Subject: **GENESIS SOLAR, LLC'S DATA RESPONSES TO CURE'S DATA
REQUEST SET 2 (1-9)
DOCKET NO. (09-AFC-8)**

**Response to CURE
Water Resources Data Requests 1 - 9**

In support of the
Application for Certification
for the
Genesis Solar Energy Project
(09-AFC-8)

GENESIS SOLAR, LLC		WorleyParsons resources & energy	
GRAVIMETRIC CROSS-SECTION LINES		SWL	NB
		52004617	9

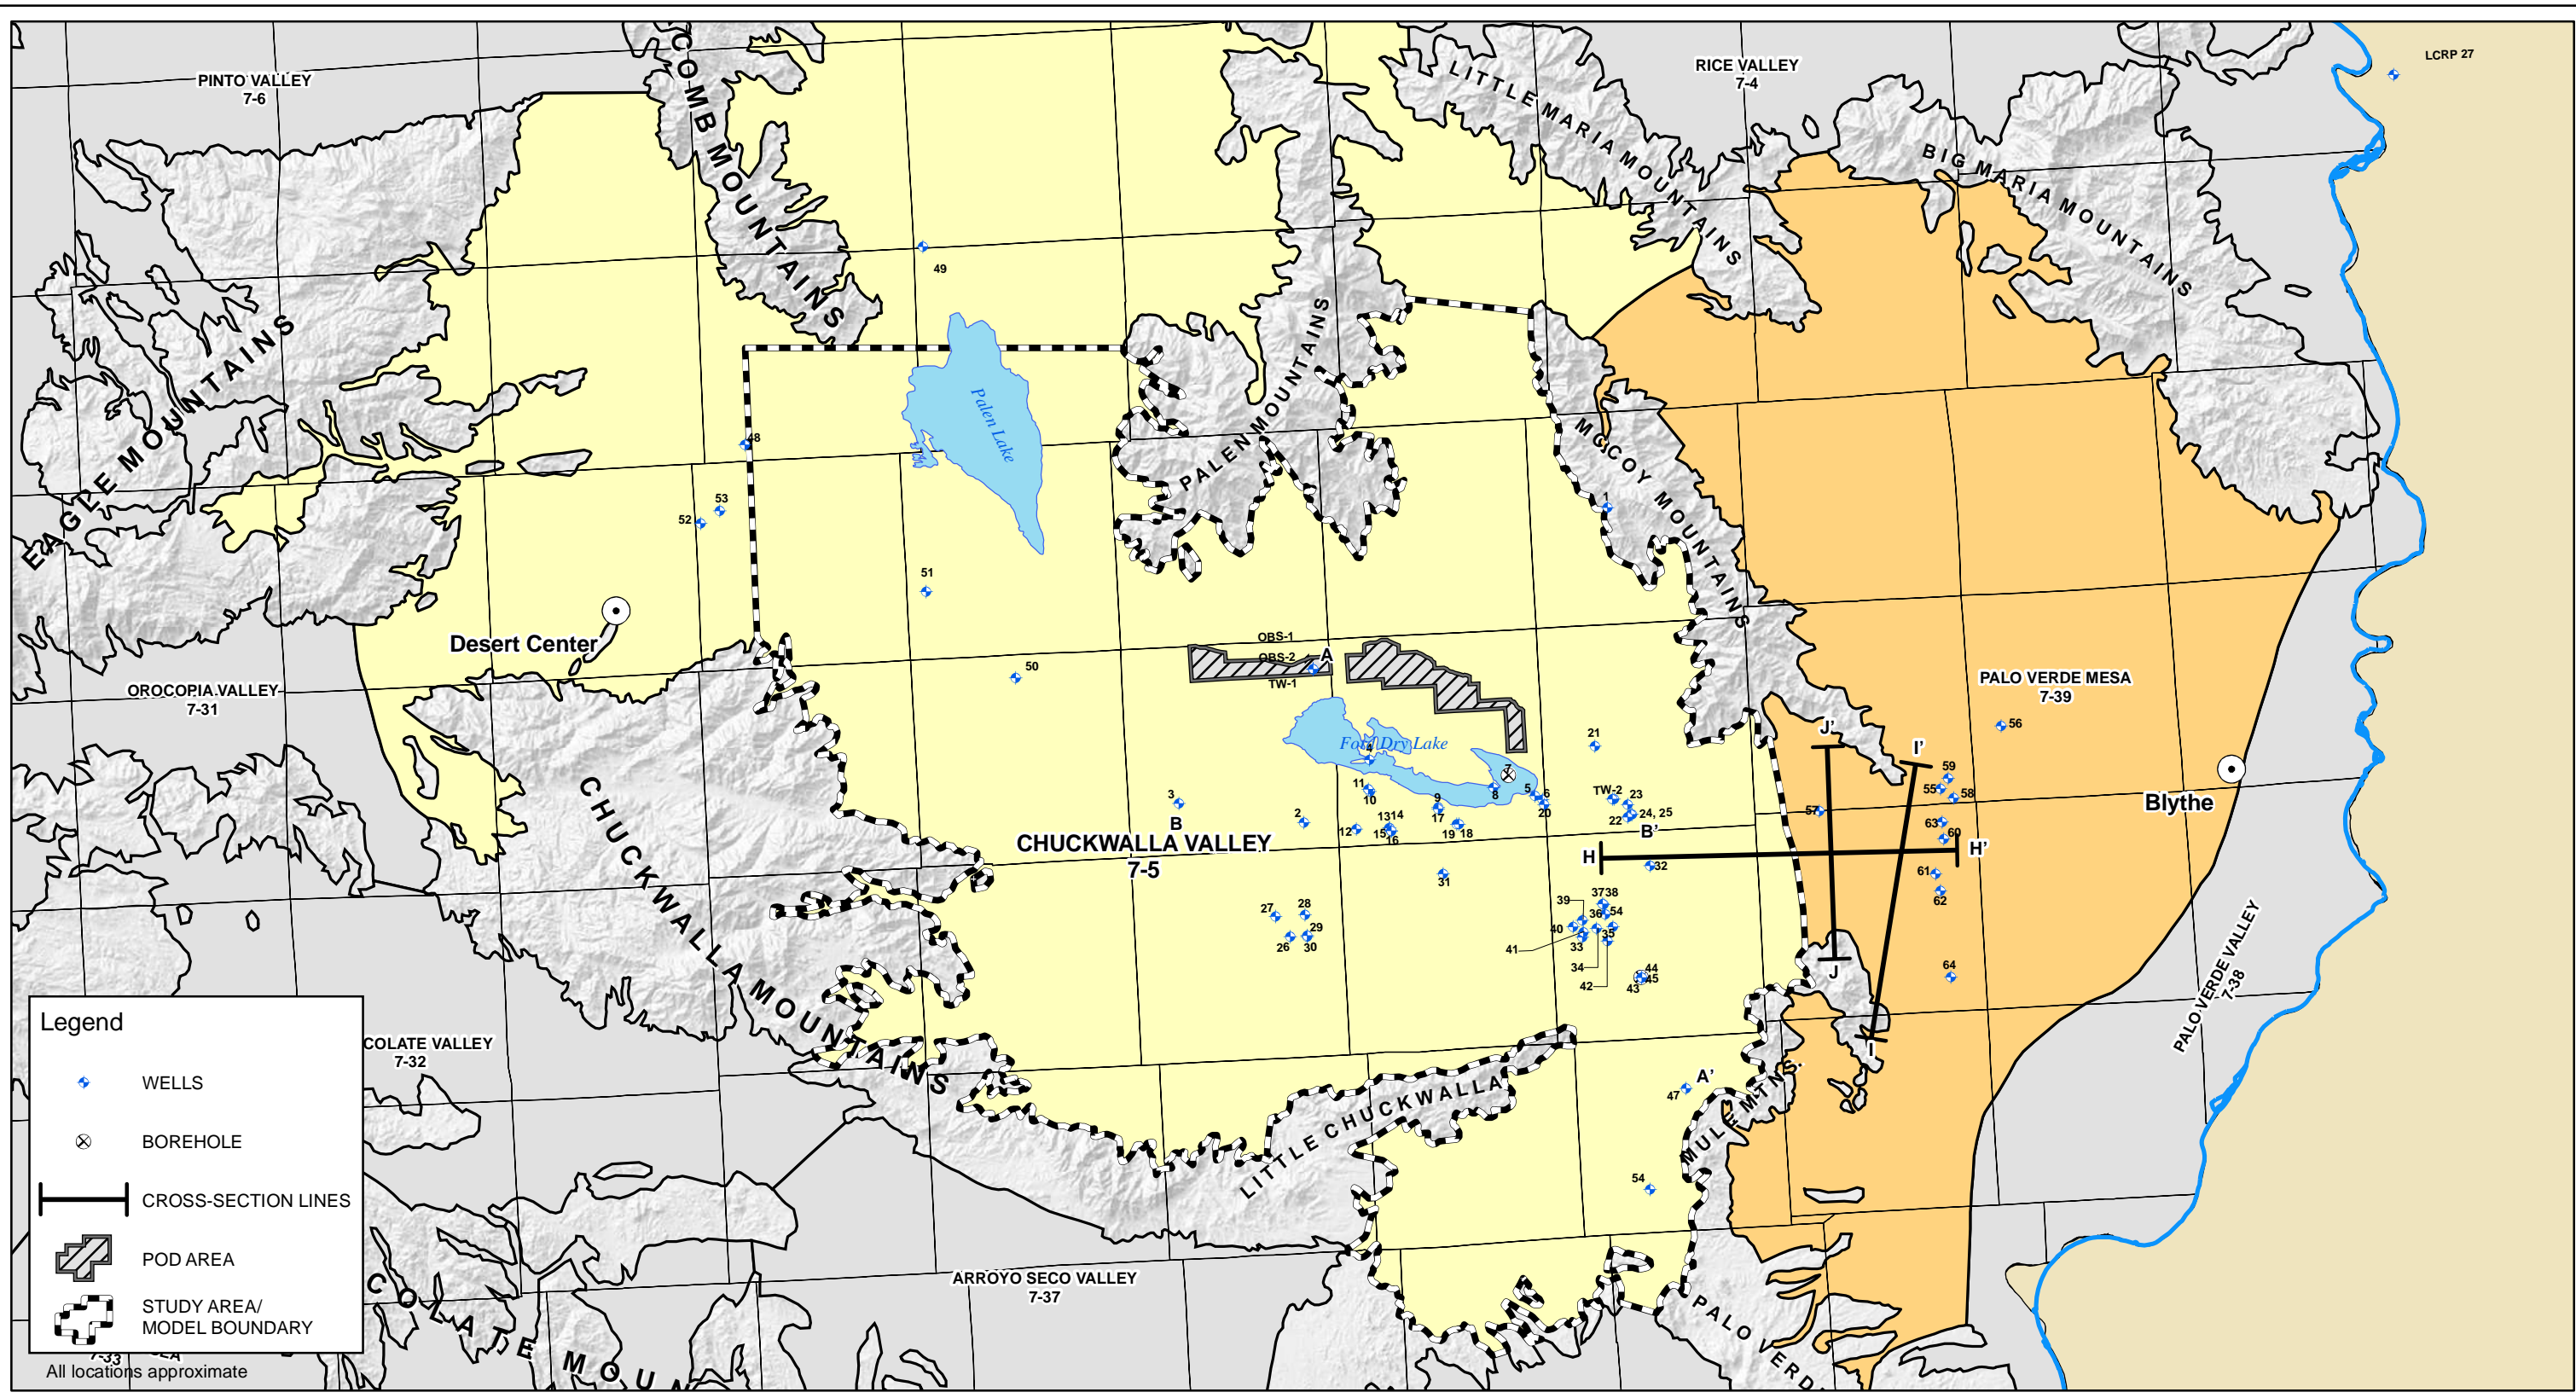
Please evaluate the potential for outflow of groundwater from the Eastern Chuckwalla Groundwater Basin to the Palo Verde Mesa Groundwater Basin, and any uncertainties in the existing data set that is currently available to evaluate the hydraulic connection between the two basins.

WorleyParsons re-examined the bedrock topography within the narrows and modeled the available gravity data to better understand the saturated cross sectional geometry of the narrows. Three cross-sections in the area connecting the Chuckwalla Valley and the Palo Verde Mesa were modeled. The modeling was refined using the approach and input parameters described in Appendix 1 of the GRI report (WorleyParsons 2010a). Primarily, the modeling was calibrated using actual bedrock depths encountered in the CVGB and a more appropriate density was used to model the metamorphic rocks underlying the basin. The locations of these cross sections are shown on Figure CDR-6-1.

Well 57 is located within the narrows (Figure CDR-6-1); however, a boring log was not available to evaluate the hydraulic properties of the water bearing sediments penetrated by this well. A boring log for Bashas's Well 3 (Metzger and others, 1973), located approximately 1 mile east of the narrows, suggests that the water bearing materials penetrated by this well may have similar hydraulic conductivities to those estimated for the CVGB. Sand and gravel strata encountered in the upper, alluvial section of this well are consistent with hydraulic conductivity values in the range of 30 ft/day or more. The lower section of this well includes interbedded sand and clay attributed to the Bouse Formation and interbedded sand, gravel and clay attributed to the Fanglomerate. The nature of these sediments appears generally similar to those encountered in the eastern CVGB, which are estimated to have an average hydraulic conductivity in the range of 12 to 14 ft/day. Based on available data, the water bearing strata between the two basins appear to be contiguous with similar hydraulic properties.

Available groundwater level data from the USGS NWIS database were evaluated for 19 wells in the vicinity of the narrows (Figure CDR-6-1; Table CDR-6-1). Data from well pairs on either side of the narrows were used to calculate average hydraulic gradients. Well pairs consist of wells with similar screened intervals and groundwater level data from similar time periods, whenever possible. The most extensive water level data were available from the fall of 1990. An average lateral hydraulic gradient ranging from 0.00046 to 0.00056 was estimated between wells 23 and 59, and wells 31 and 59, respectively (Table CDR-6-2). These wells generally represent conditions above a depth of 700 feet bgs. An average lateral hydraulic gradient ranging from 0.00021 to 0.00025 was estimated between wells 33 and 62 and wells 36 and 62, respectively. These wells generally represent the lateral hydraulic conductivity below 700 feet bgs. These hydraulic conductivities are similar to the range discussed by Metzger and others (1973), which is 2 to 3 feet per mile, or 0.00038 to 0.00057; however, it appears that the gradient decreases with depth.
